City of Puyallup  
Development  
Engineering  
APPROVED

WASHINGTON STATE FAIR  
GOLD GATE - CANOPY  
110 9TH AVE SW  
PUYALLUP, WA 98371

SITE PLAN  
BOLLARD & PAVING

A1.4

SITE PLAN - BOLLARD & PAVING  
(11X17) SCALE: 1" = 20'  
(22X34) SCALE: 1" = 10'

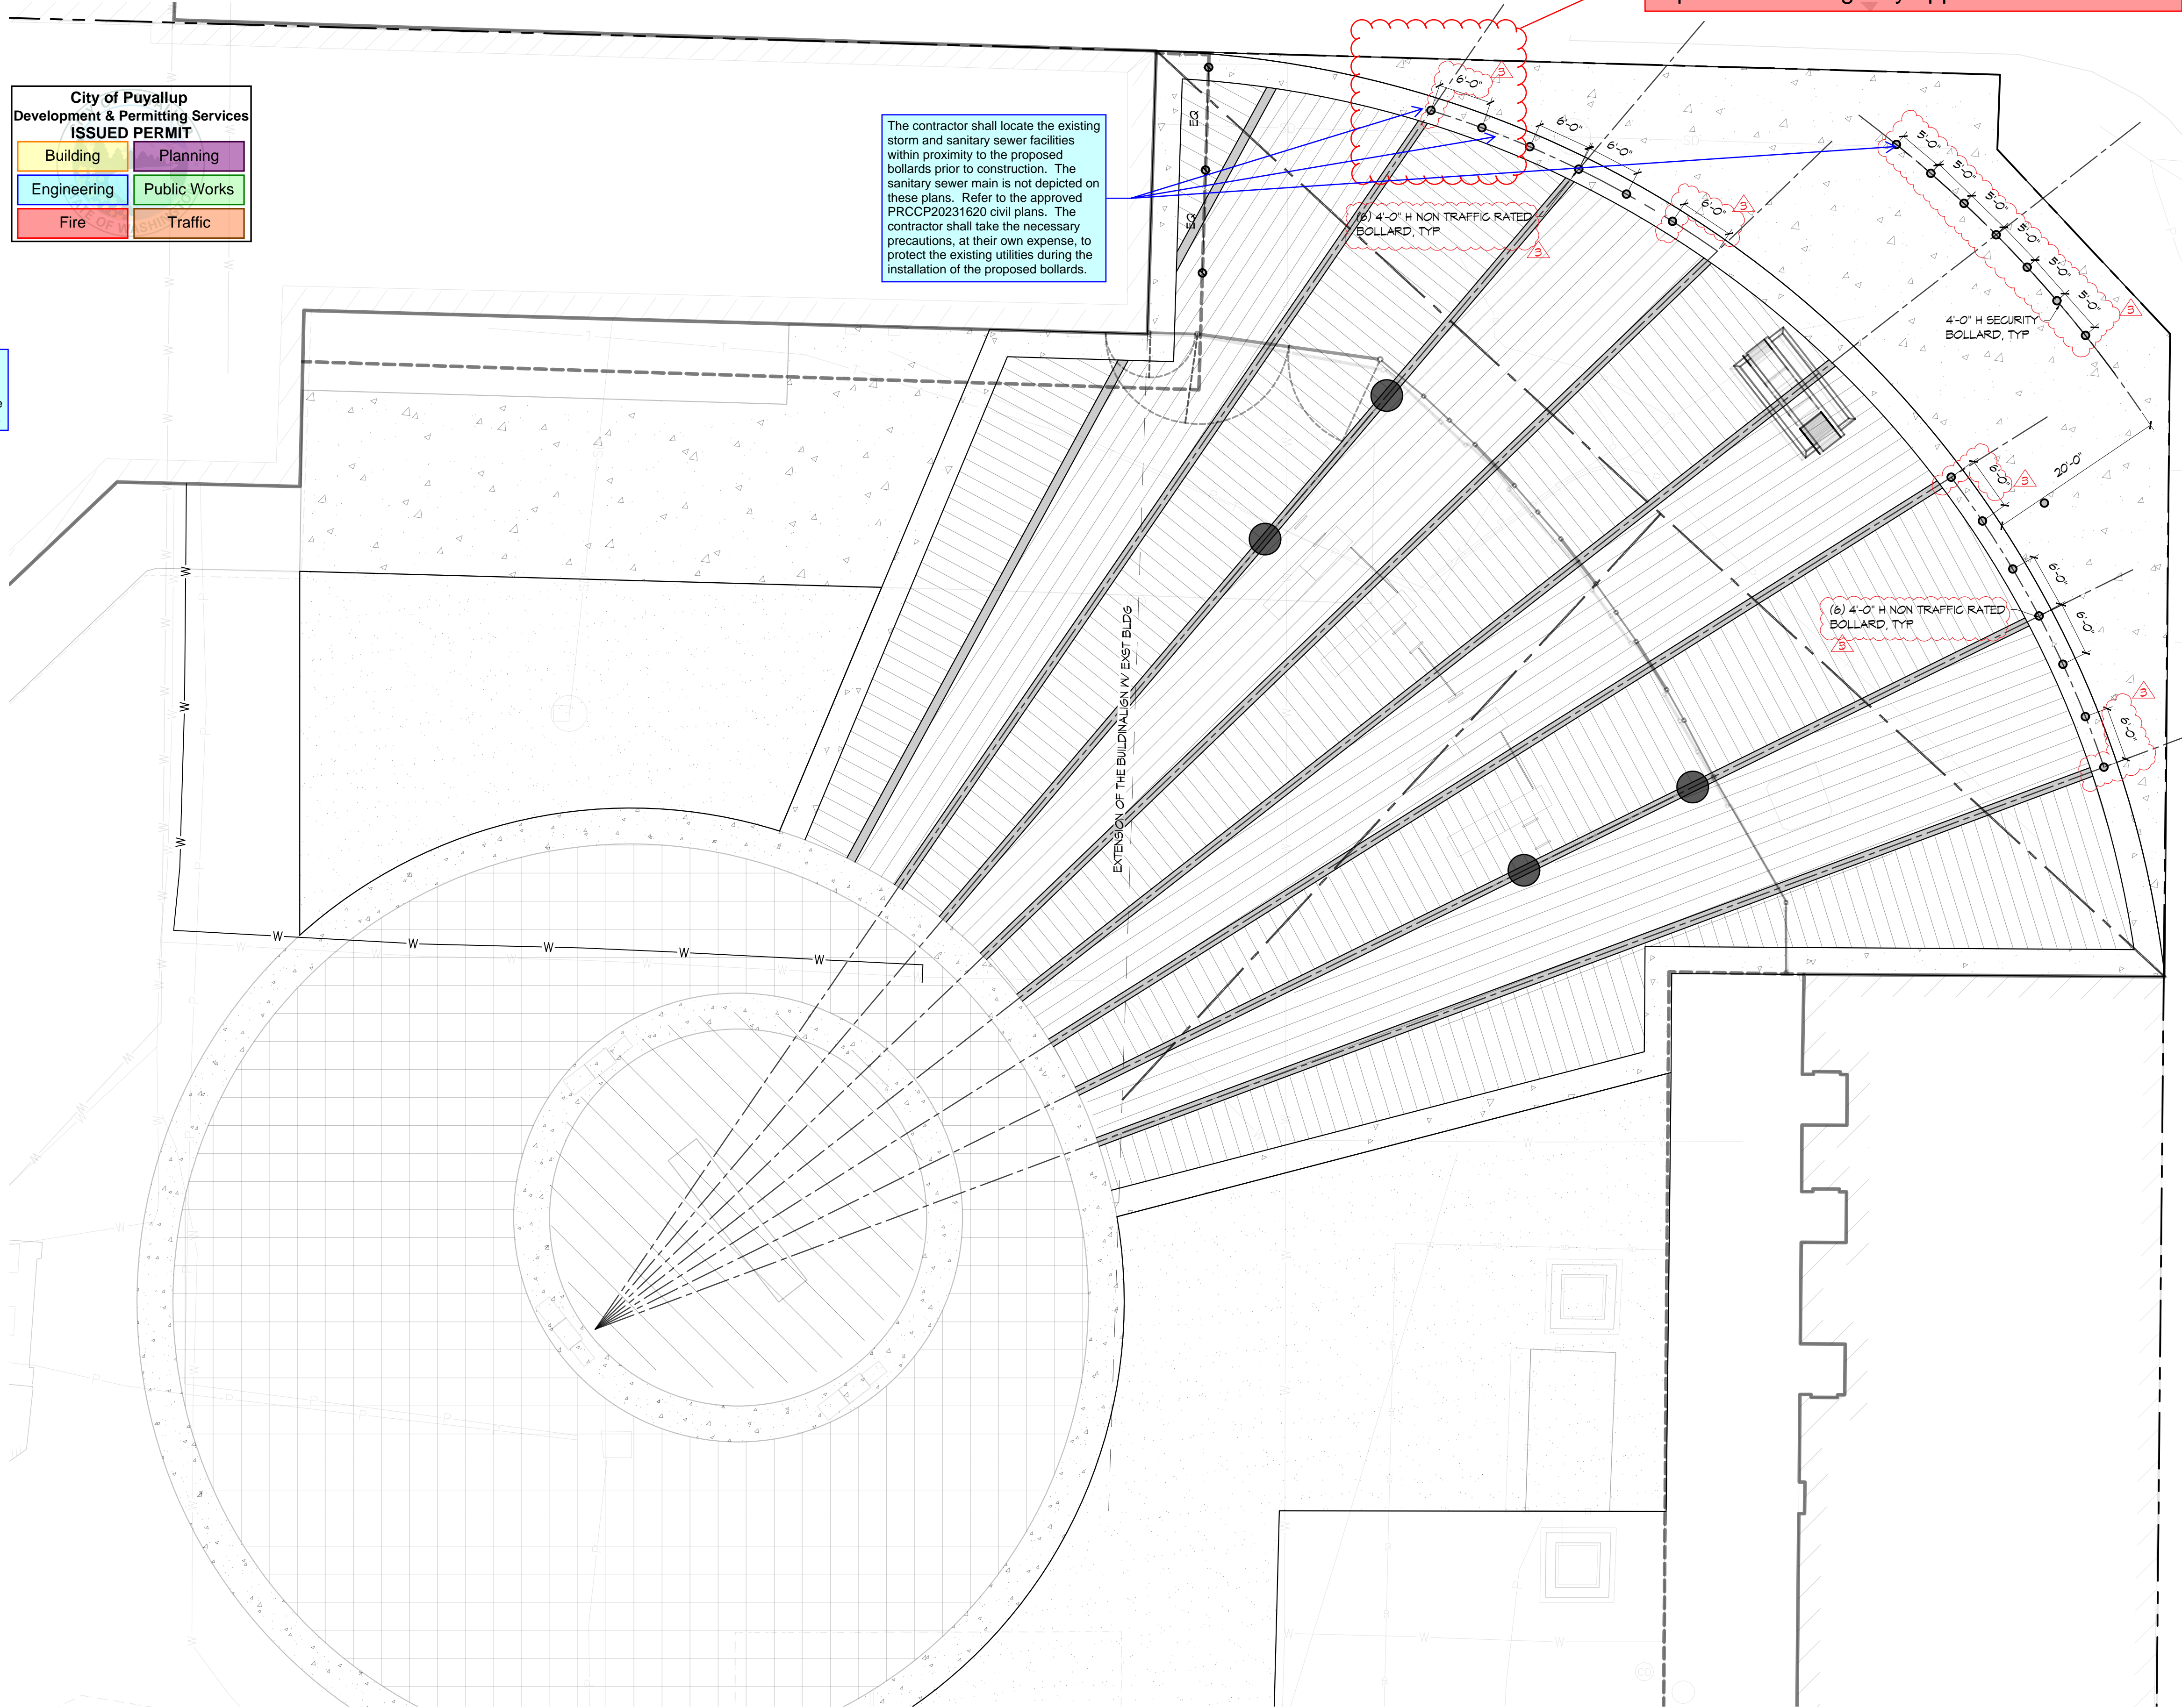
No proposed footings, posts, or supports shall be constructed on or above any existing public utility connections without first relocating the utility services or protecting it in place.

The contractor shall locate the existing storm and sanitary sewer facilities within proximity to the proposed bollards prior to construction. The sanitary sewer main is not depicted on these plans. Refer to the approved PRCCP20231620 civil plans. The contractor shall take the necessary precautions, at their own expense, to protect the existing utilities during the installation of the proposed bollards.

Bollards may be required to be removed if they impede the Emergency apparatus access.
